Tyres: UN Regulation No. 141 (Tyre pressure monitoring systems)

Proposal for supplement 3 to 01 Series of Amendments to Regulation No. 141

Submitted by the Task Force Tyre Pressure Monitoring System and Tyre Installation (TF TPMSTI)¹

“**Figure 1**
Refilling check

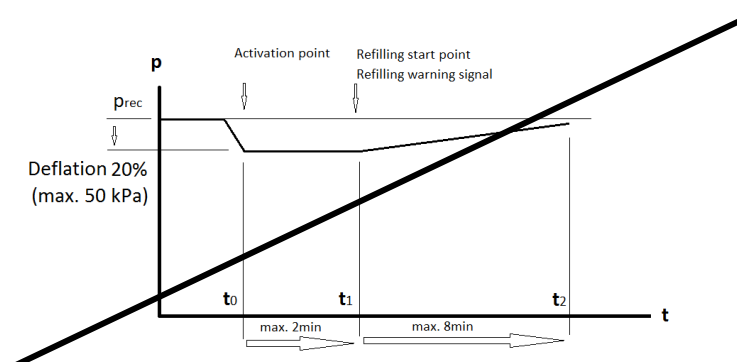
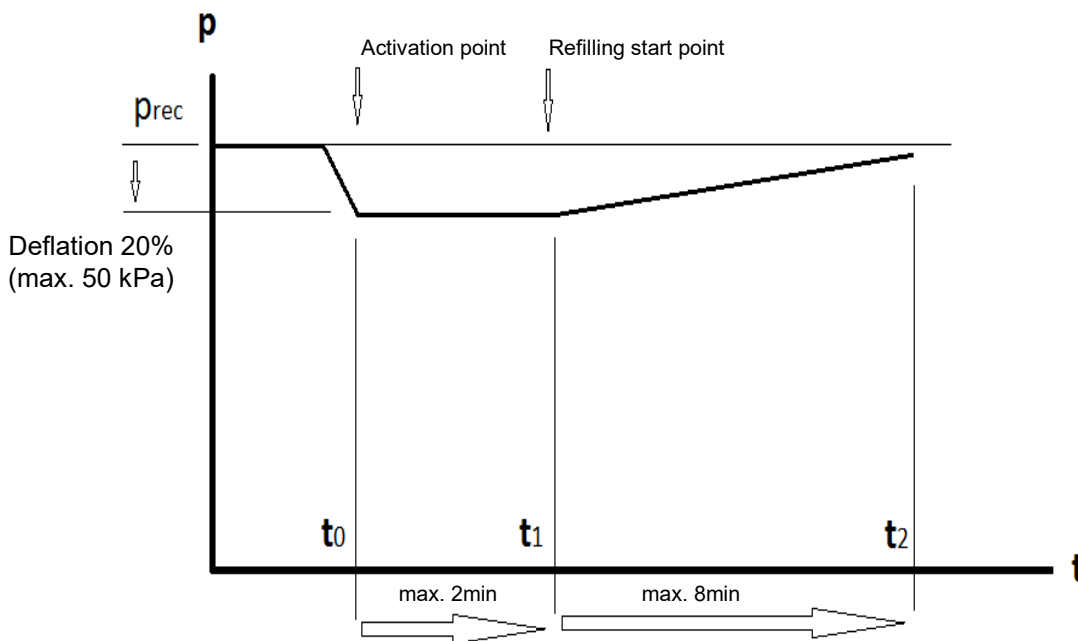
“2.25.1. Check refilling according to Figure 1

Check that within 2 minutes, when the system is operational, the TPRS/CTIS starts refilling and at least after 2 minutes the low tyre pressure tell-tale, as described in paragraph 5.5. of the Regulation, is “On”.

Refill process shall be completed within 8 min after the refill process has started and the low tyre pressure tell-tale, as described in paragraph 5.5. of the Regulation, is “Off” as soon as the refilling process is completed.

After the refilling process has been completed, check that the tyre pressure is in a range of +/- 5% of manufacturers recommended cold inflation pressure P_{rec} .”

Annex 4, Figure 1 to be replaced by a new Figure 1, amend to read:

“Figure 2

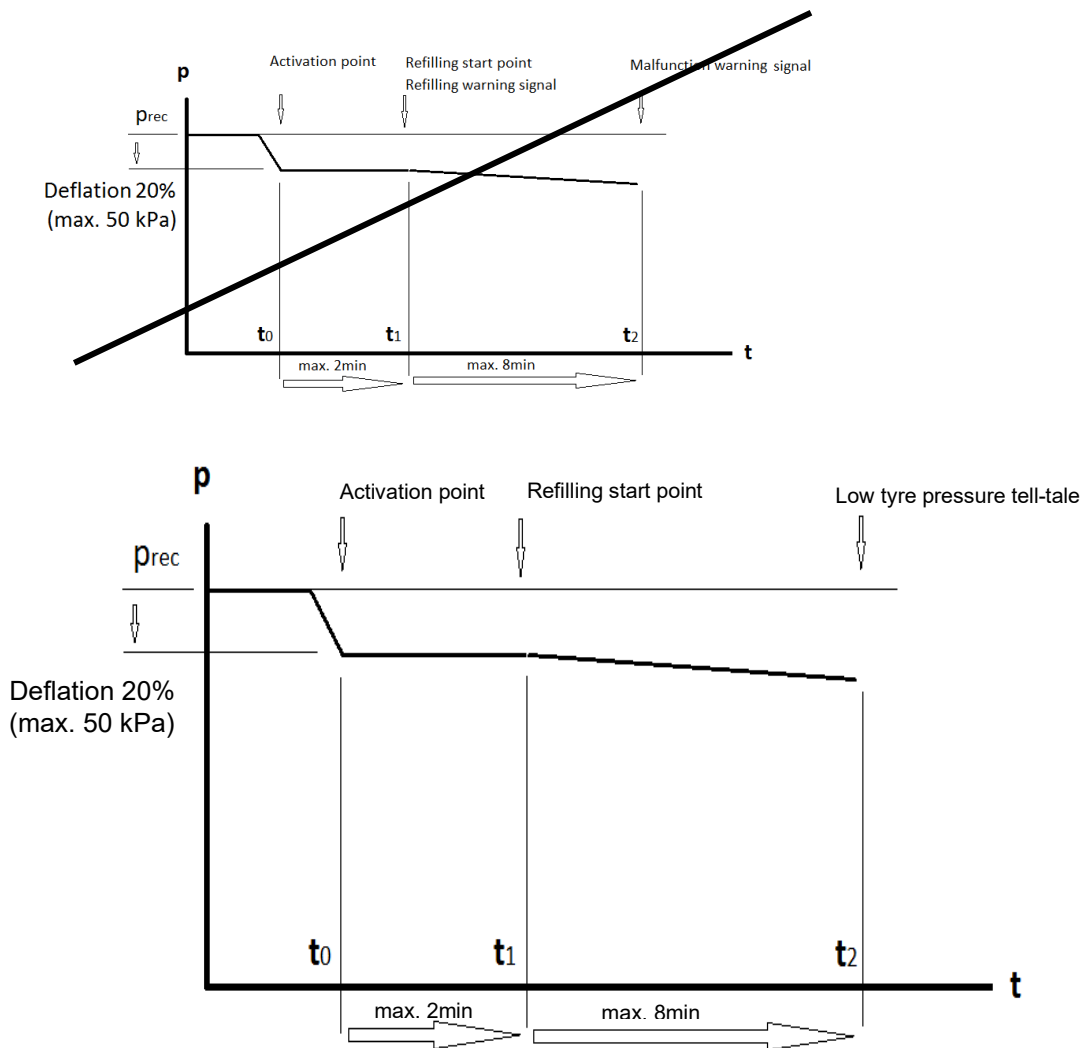
~~“2.3. Check system malfunction warning functionality according to Figure 2~~

~~Constantly deflate the system or the pressure of one tyre by 20% but not more than 50 kPa below the manufacturers recommended cold inflation pressure (P_{rec}).~~

~~Within 2 minutes the system shall start refilling and the optical signal as described by the manufacturer for refilling is be ON~~

~~Within 8 minutes after the start of the refilling the optical signal for malfunction as described by the manufacturer shall be ON.”~~

Annex 4, Figure 2 to be replaced by a new Figure 2, amend to read:

“Figure 1
Arrangement of device under test and vehicle simulator where TPMS/ TPRS/ CTIS functionality is provided by ECU connected via ISO 11898-1:2015 and 11898-2:2016 interface

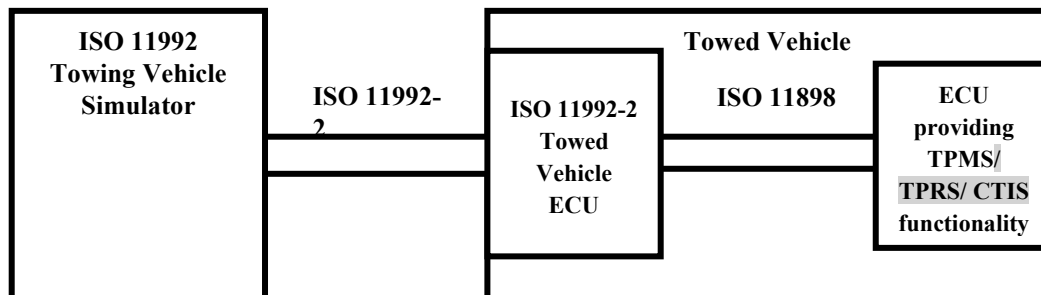
Annex 6, Figure 1, amend to read:

“Figure 2
Arrangement of device under test and vehicle simulator where TPMS/ TPRS/ CTIS functionality is provided by ECU connected to towing vehicle

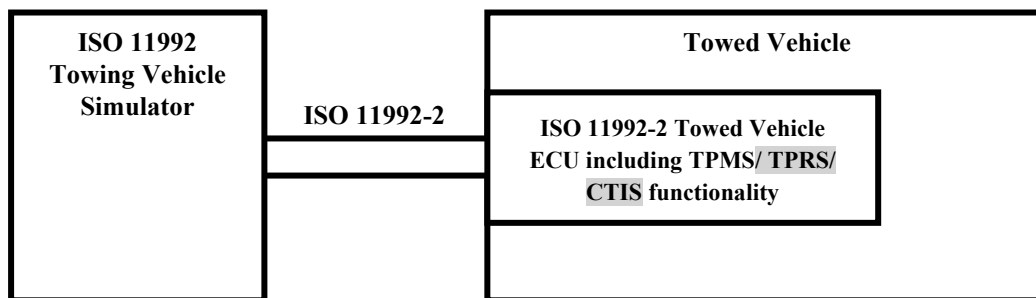
Annex 6, Figure 2, amend to read:
